## HISTORIC AND DESIGN REVIEW COMMISSION

December 15, 2021

**HDRC CASE NO:** 2021-622  
**ADDRESS:** 305 SOLEDAD ST  
**LEGAL DESCRIPTION:** NCB 154 (HALFF SUBD), LOT 17, P-100(PORION OF N MAIN AVE) & P-101(PORION OF SOLEDAD ST)  
**ZONING:** D, RIO-3  
**CITY COUNCIL DIST.:** 1  
**APPLICANT:** Randy Smith/305 SOLEDAD LOT LTD  
**OWNER:** Randy Smith/305 SOLEDAD LOT LTD  
**TYPE OF WORK:** Construction of a 32-story residential tower  
**APPLICATION RECEIVED:** November 29, 2021  
**60-DAY REVIEW:** Not applicable due to City Council Emergency Orders  
**CASE MANAGER:** Edward Hall

The applicant is requesting a Certificate of Appropriateness for approval to construct a thirty-two (32) story residential tower on the vacant lot addressed as 305 Soledad. The lot is bounded by Soledad Street to the east, Pecan Street to the north, Main Avenue to the west and Travis Street to the south. The proposed new construction will feature 354 residential units, 456 parking spaces and approximately 6,275 square feet of ground floor retail space.

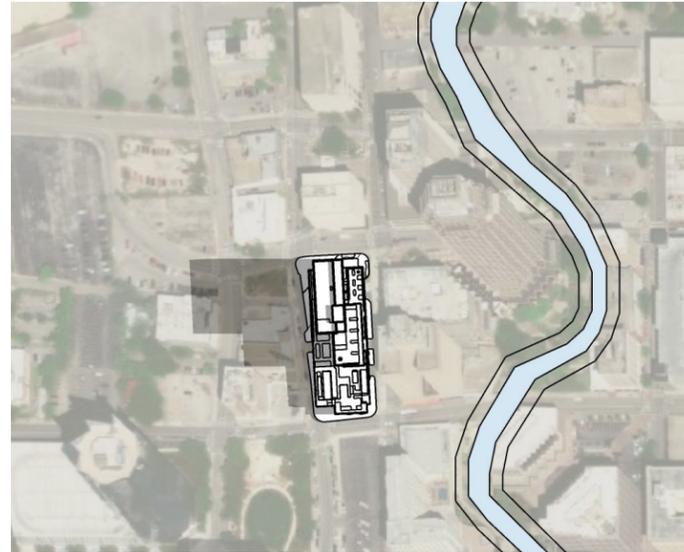
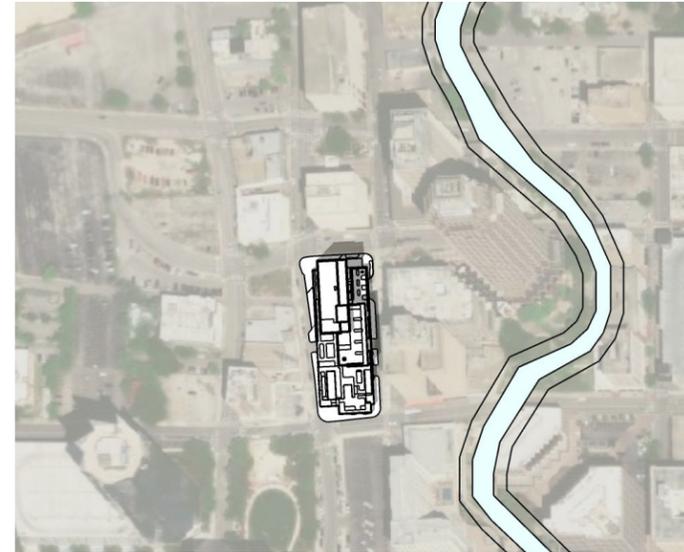
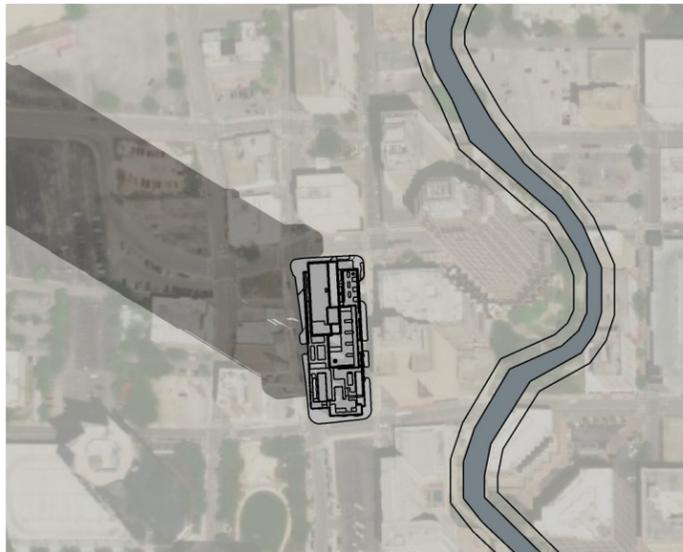
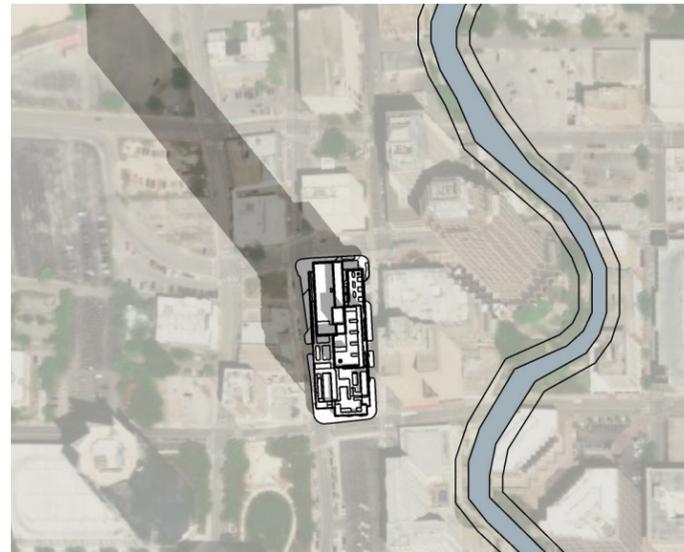
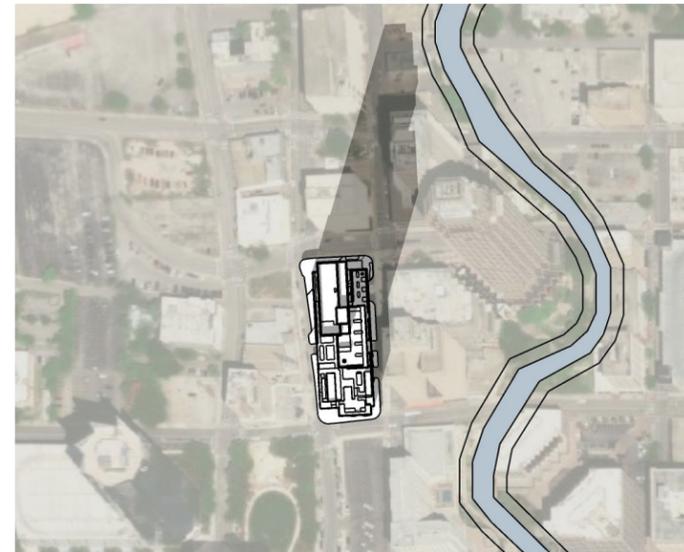
*\*Meets minimum daylight requirements of 7.5 hours of daylight 30' from river bank at Summer Solstice*
